US DEPARTMENT OF ENERGY
HANFORD WASTE VITRIFICATION PLANT

DESIGN CHANGE NOTICE

DCN - 0189

HWMA WATER
SUPPLY

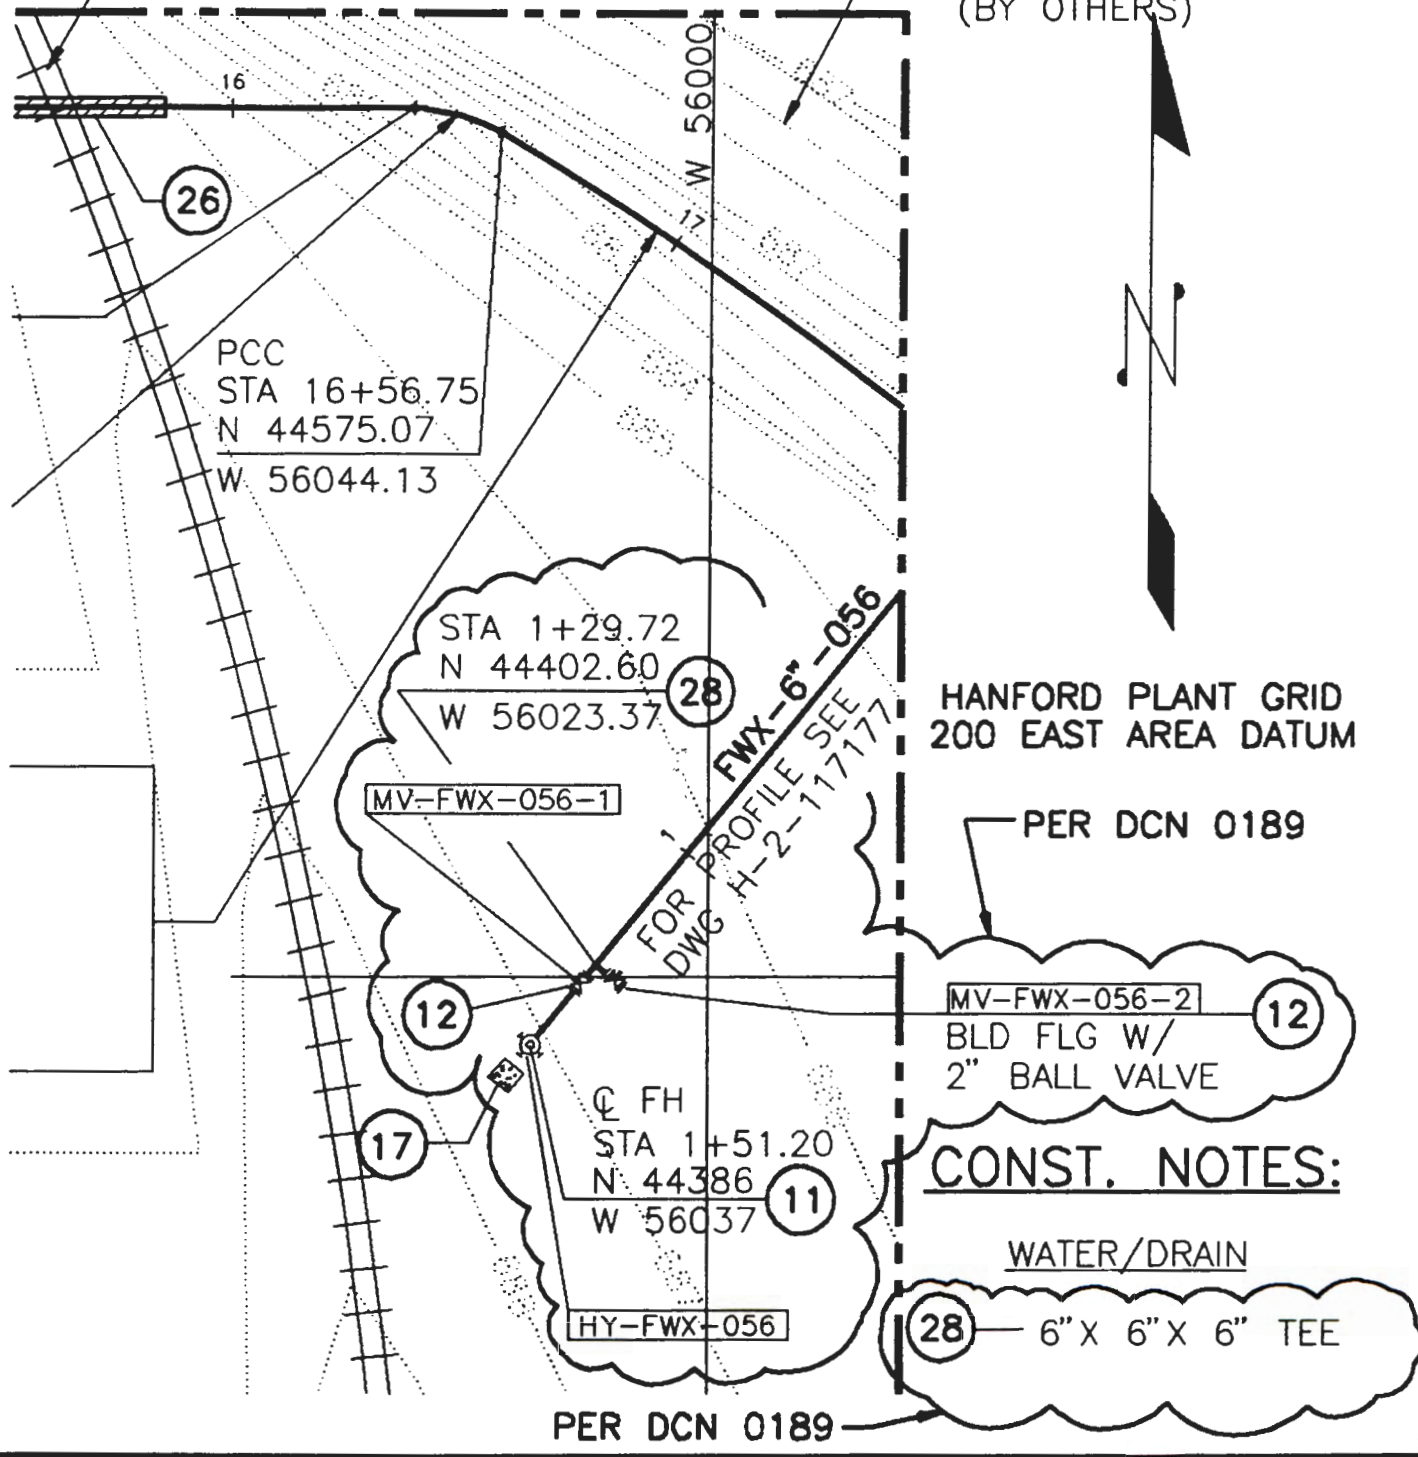
DOCUMENT NUMBER	SHT/PAGE	REV NO	DOCUMENT NAME	INCLD Y/N	DESCRIPTION OF CHANGE
H-2-117152	1	4	CIVIL, UNDERGROUND UTILITY PLAN	Y	PROVIDE NEW TEE AND VALVE, MV-FWX-056-2, IN PIPELINE FWX-6"-056 (ZONE F4) AND RELOCATE VALVE MV-FWX-056 FROM DWG H-2-117153 AND RENUMBER TO MV-FWX-056-1
H-2-117153	1	5	CIVIL, UNDERGROUND UTILITY PLAN	Y	RELOCATE VALVE MV-FWX-056 (ZONE F8) TO DWG H-2-117152
H-2-117177	1	3	CIVIL, SWX, FWX, AND DRX PIPE PROFILES	Y	PROVIDE NEW TEE AND RELOCATED PIV VALVE IN PROFILE FWX-6"-056

PER DCN 0189

MV-FWX-056-2 (12)
 BLD FLG W/
 2" BALL VALVE

(28) — 6" X 6" X 6" TEE

PER DCN 0189

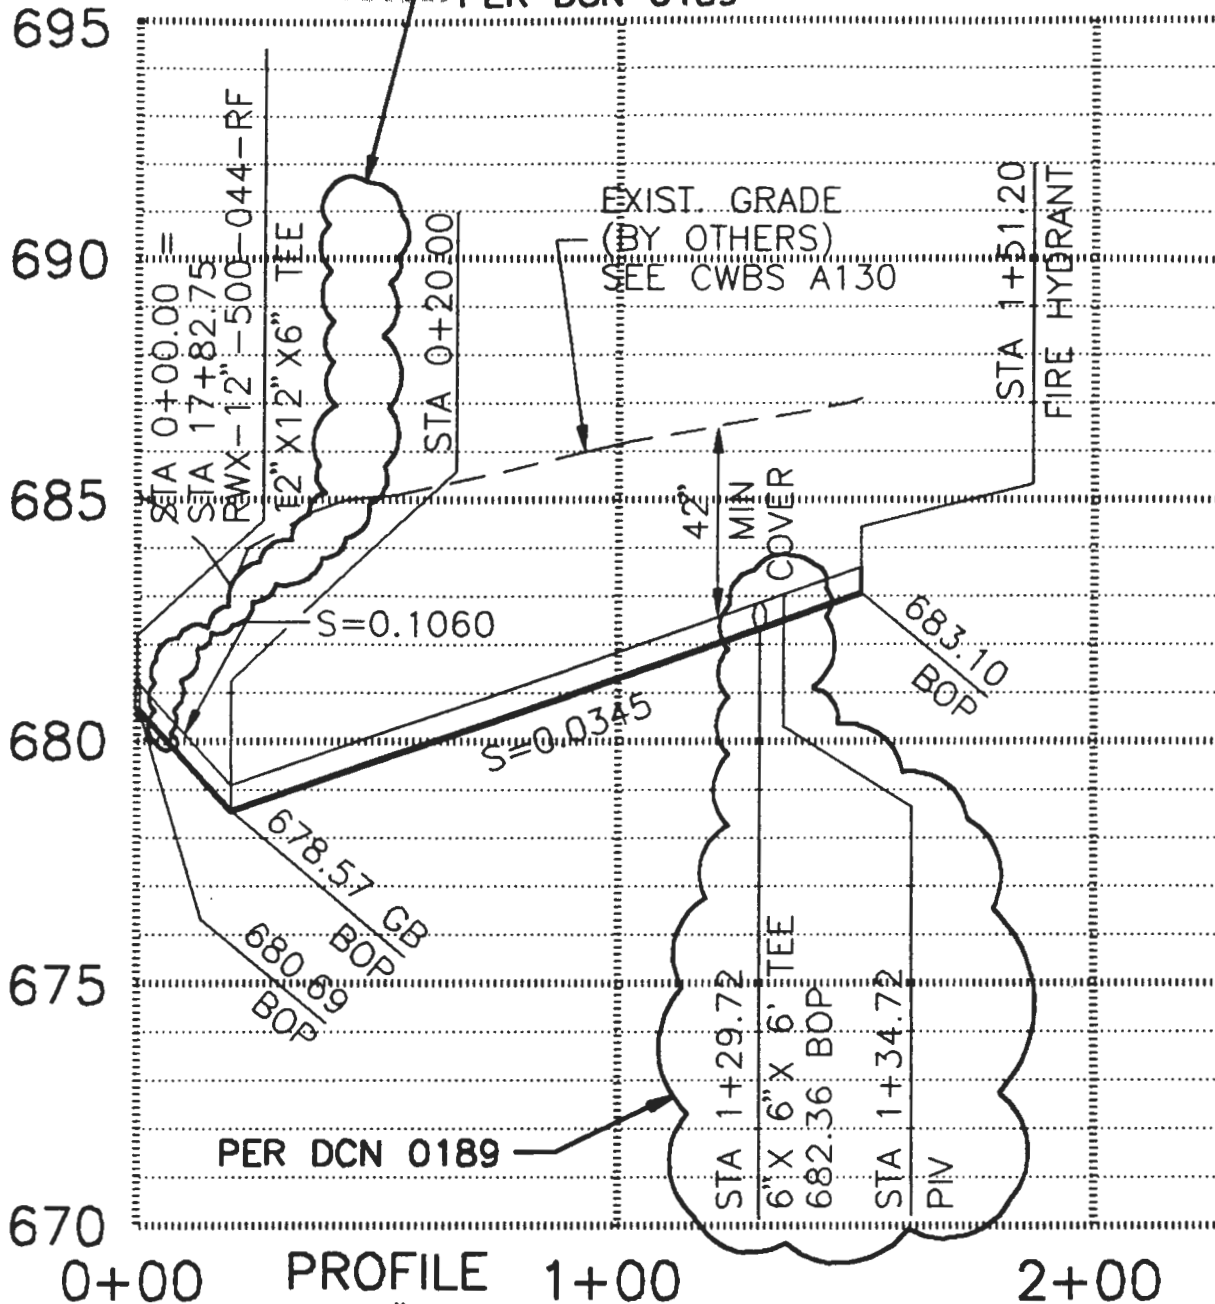
9513358.0697 PER DCN 0189

FWX-6"-056
 HORIZ. 1"=40'
 VERT. 1"=4'
